PARTIAL ANCHOR BOLT SETTING PLAN (LEVEL-M3) (SECTOR-A)
(REFER SHEET: S-A-2522)

PARTIAL ANCHOR BOLT SETTING PLAN (LEVEL-M3) (SECTOR-A)
(REFER SHEET: S-A-2512 & S-A-2534)

ANCHOR BOLT SETTING KEY PLAN (SECTOR A-B-C)

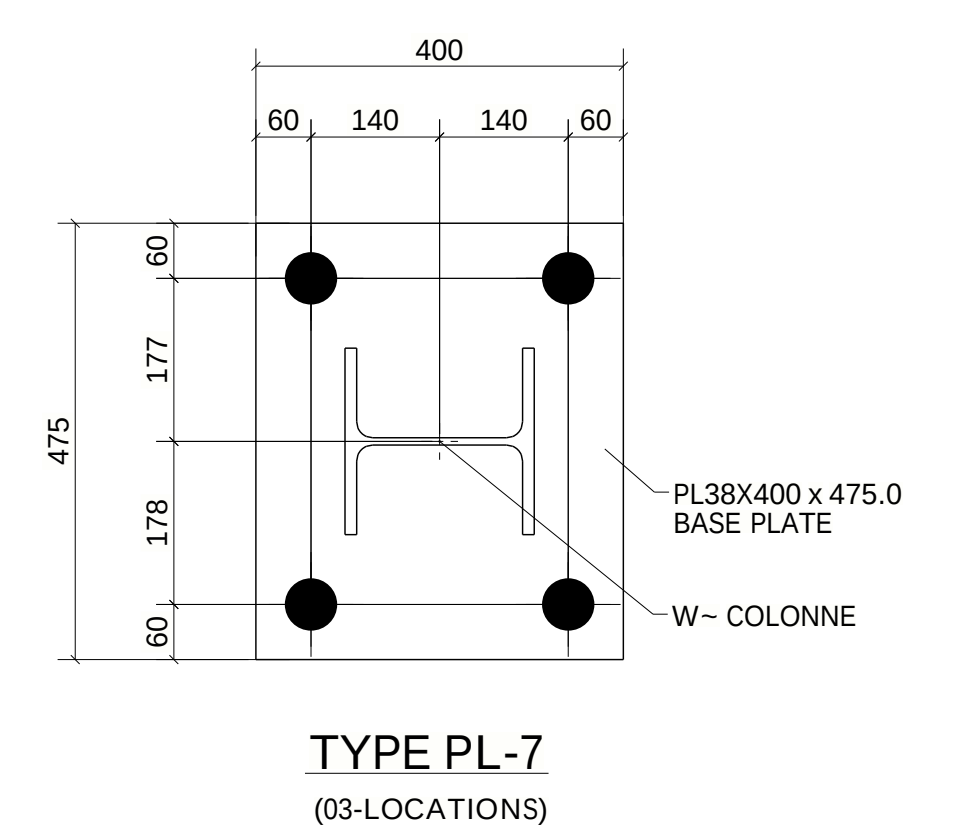
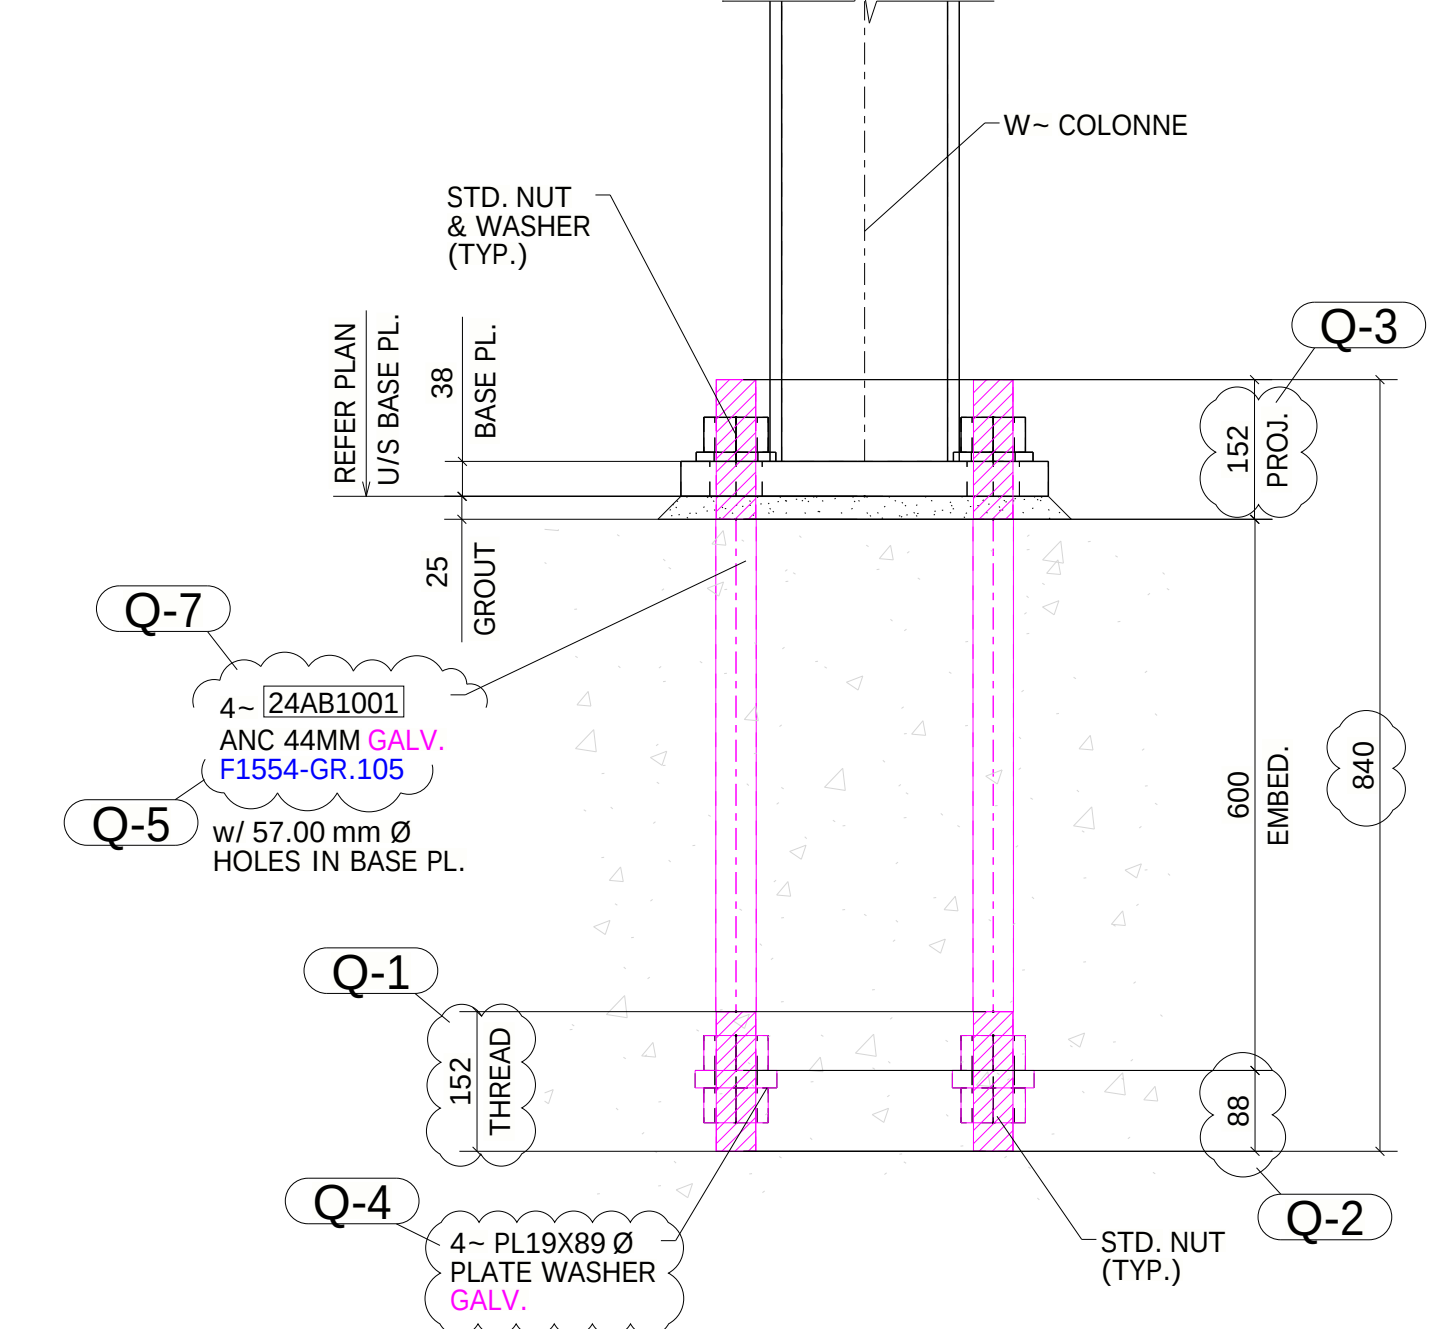
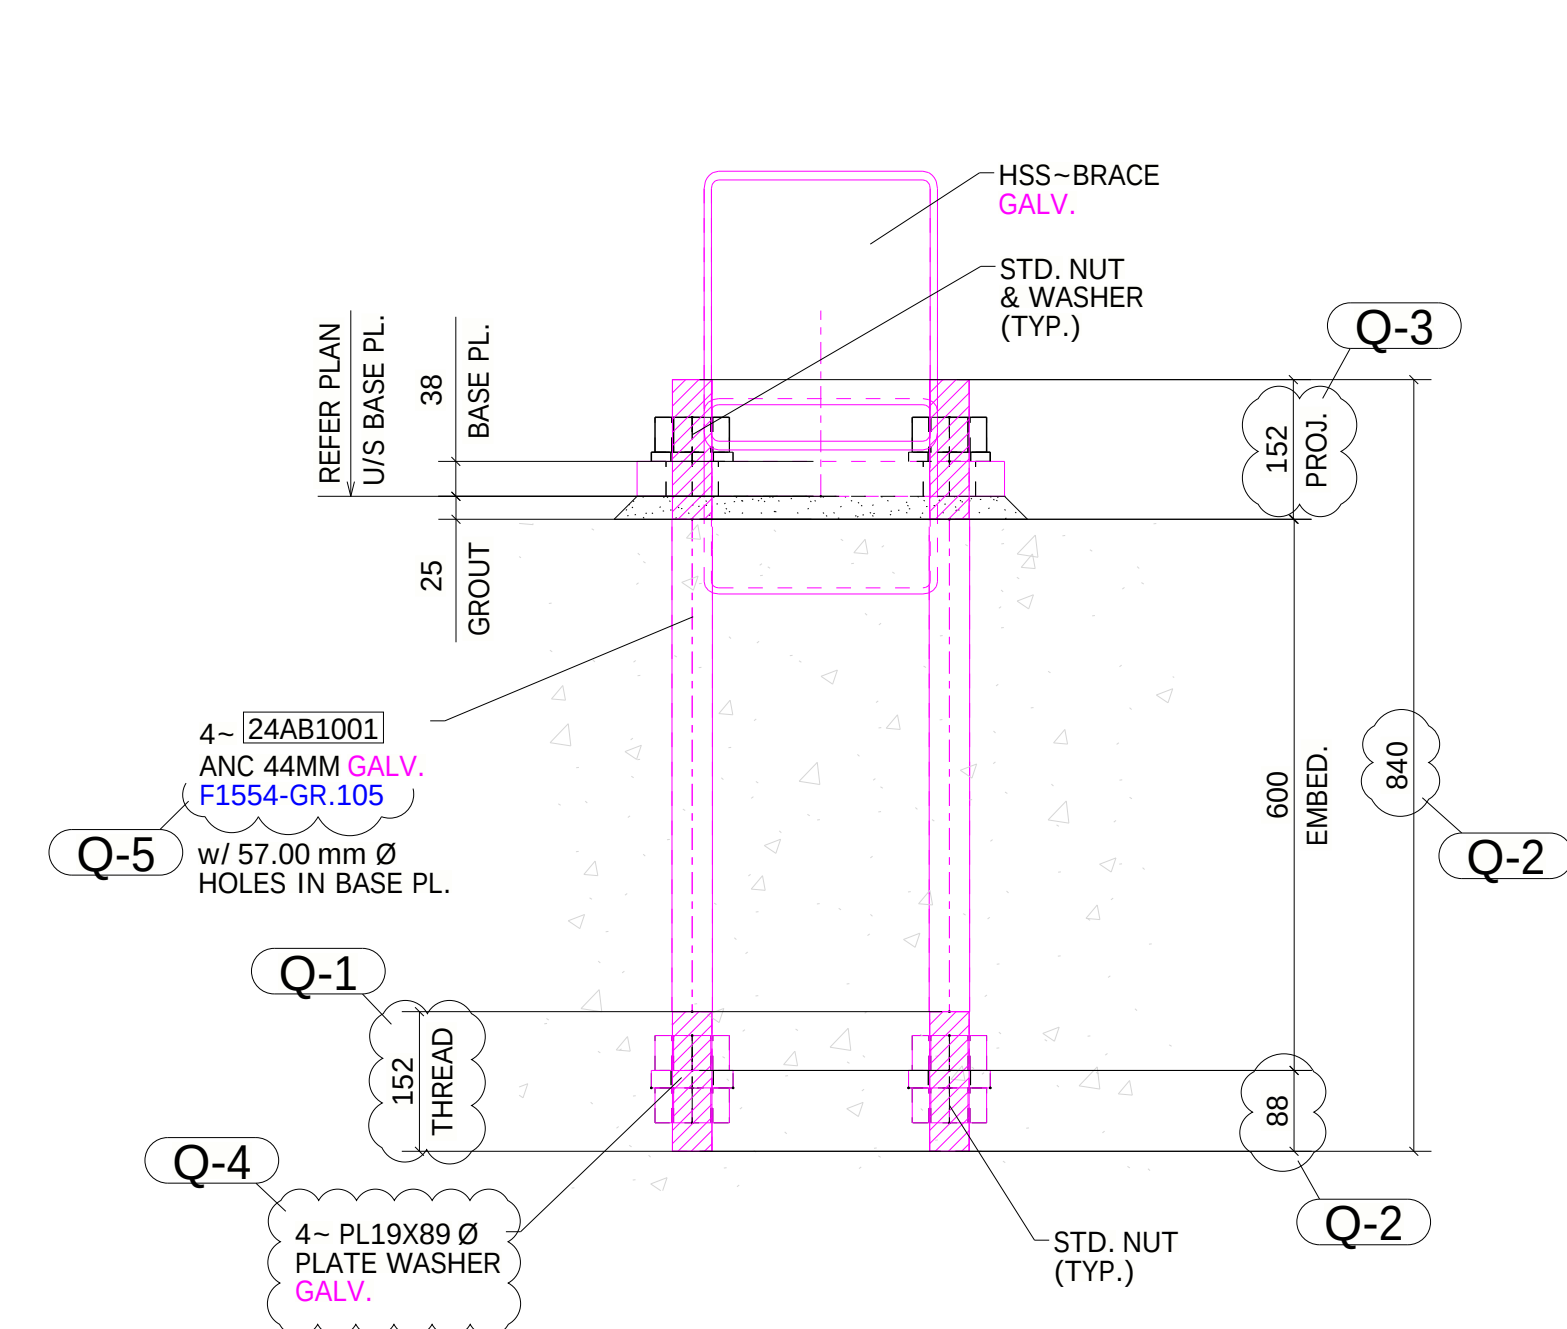
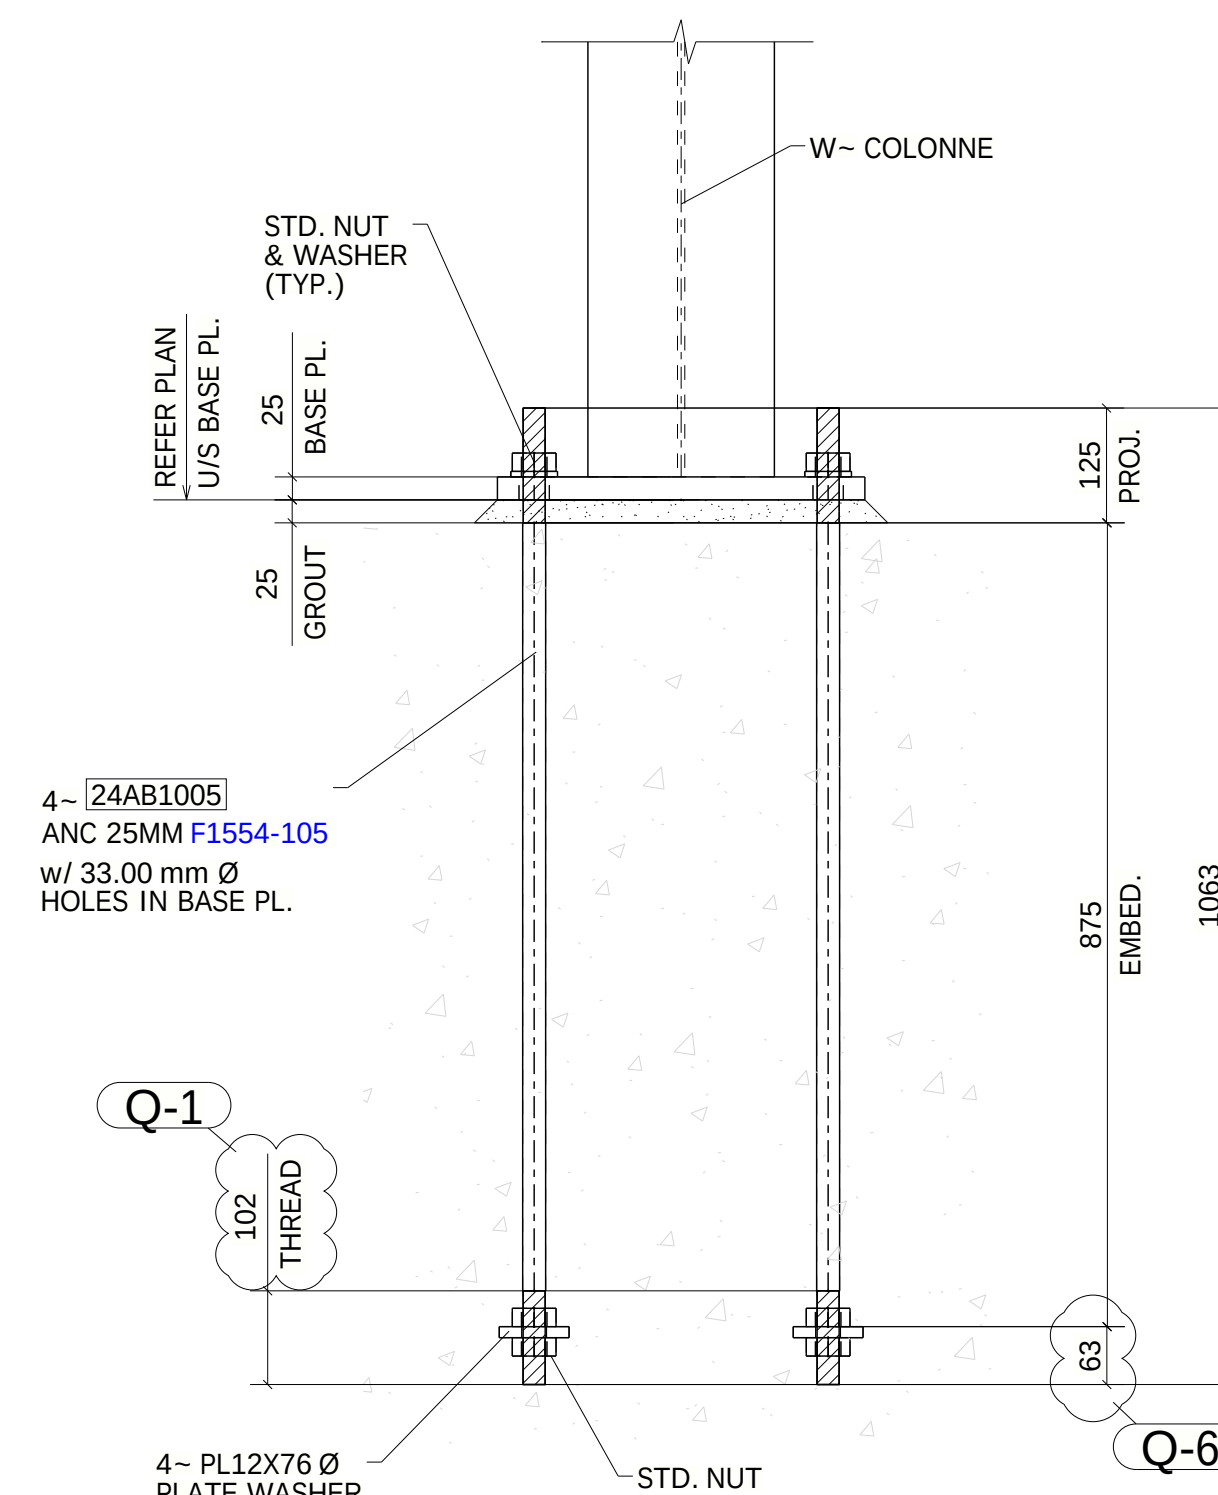
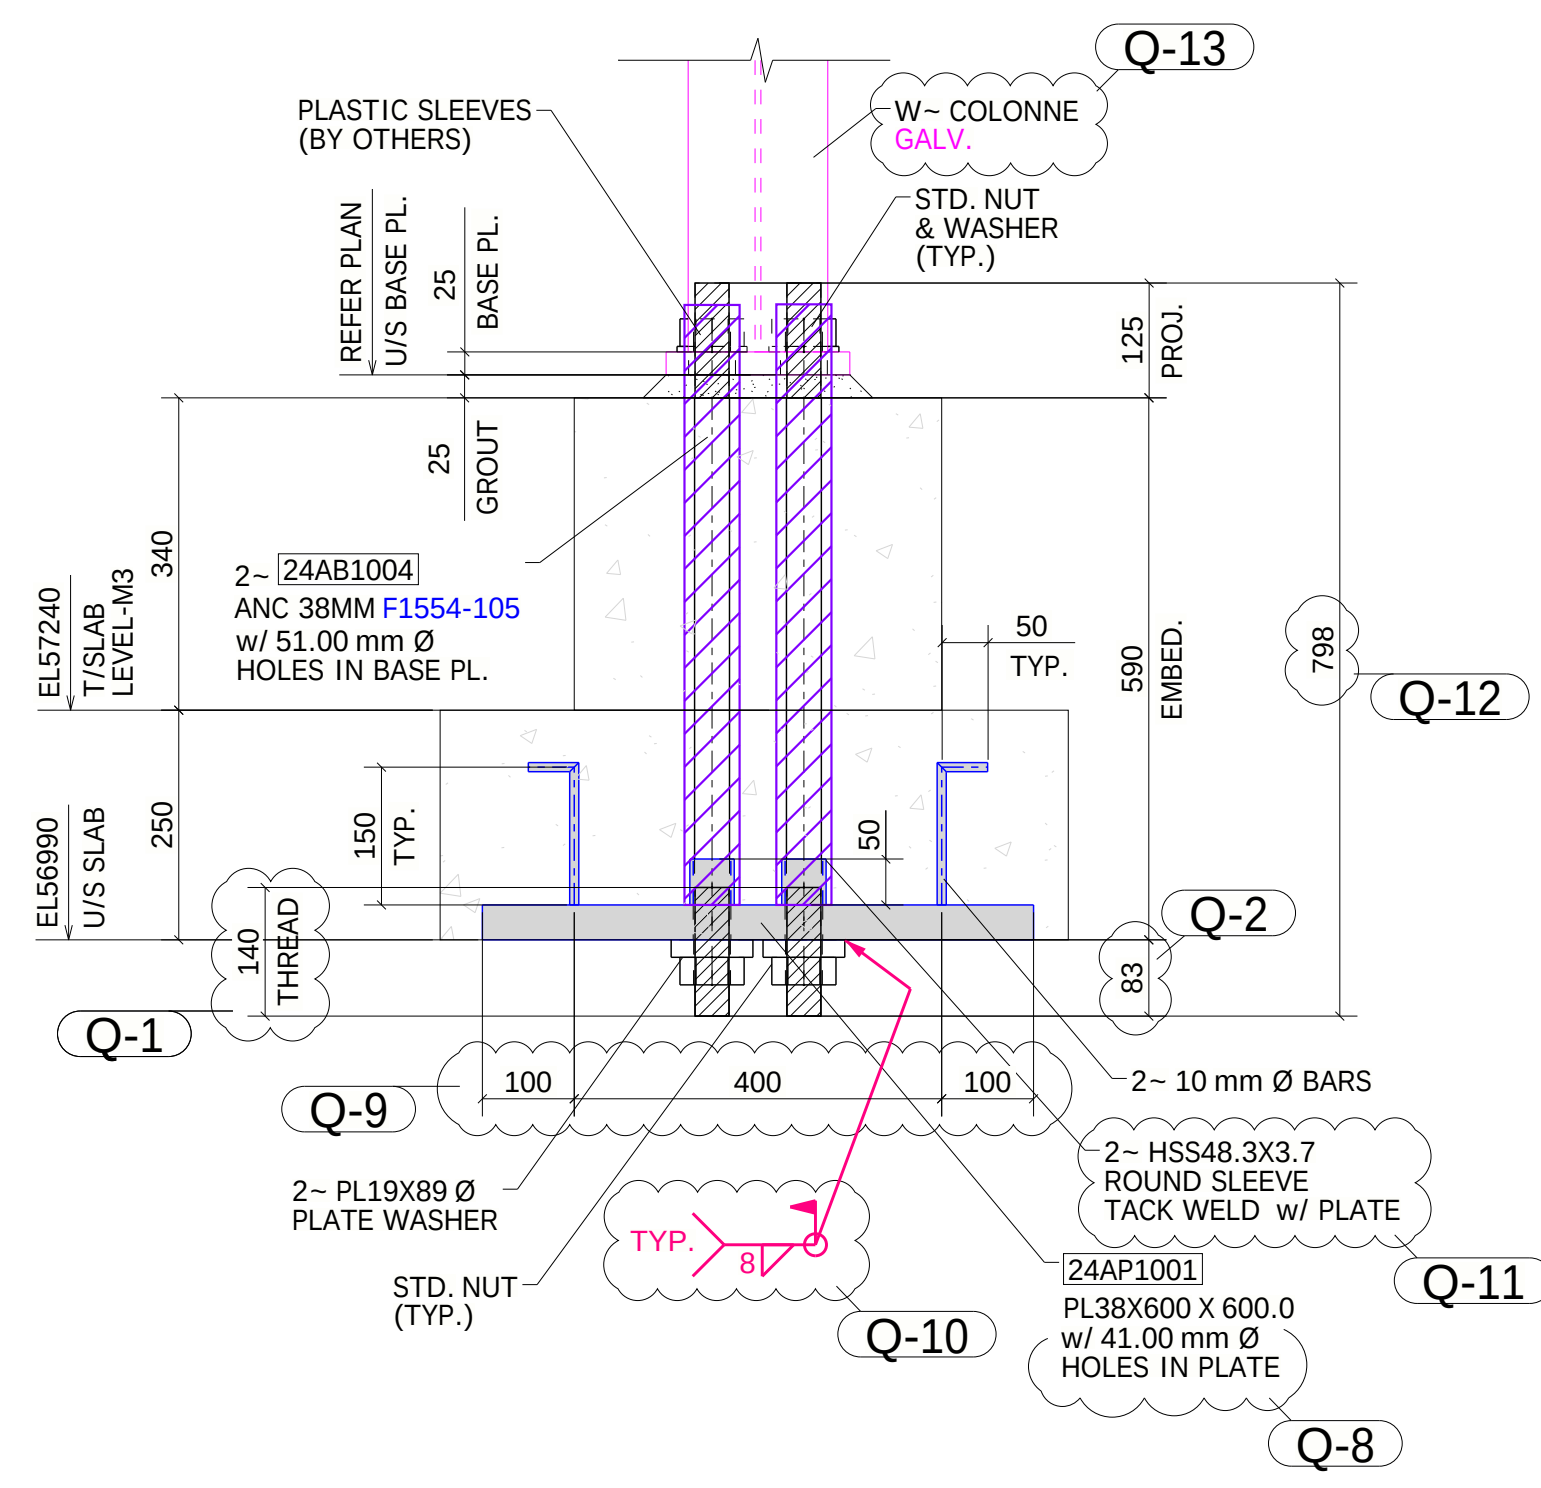
APPROVER VERIFY BASE PLATE TYPE USED AT THIS LOCATIONS.
SINCE STRL.SHEETS DOES NOT HAVE CLEAR INFORMATION.

APPROVER VERIFY COLUMN LOCATING DIMENSIONS.
SINCE STRL.SHEETS DOES NOT HAVE CLEAR INFORMATION.

APPROVER VERIFY BASE PLATE TYPE FOLLOWED (TYPE PL-6) WITH EMBEDMENT OF 300mm AT THIS LOCATION. SINCE WE ARE HAVING ONLY 250mm THICK SLAB. PLEASE SUGGEST HOW TO PROCEED WITH ANCHOR ROD LENGTH.

APPROVER VERIFY U/S OF BASE PL. ELEVATION.SINCE
STRL. PLAN (S-A-2523) DOES NOT SHOWS ANY PIER
AT THIS LOCATION. PLEASE VERIFY AND CONFIRM.

APPROVER VERIFY ALL UNDER SIDE OF
BASE PLATE ELEVATION,TYPE & ORIENTATION.

APPROVER VERIFY/FURNISH
ALL CLOUDED INFORMATIONS
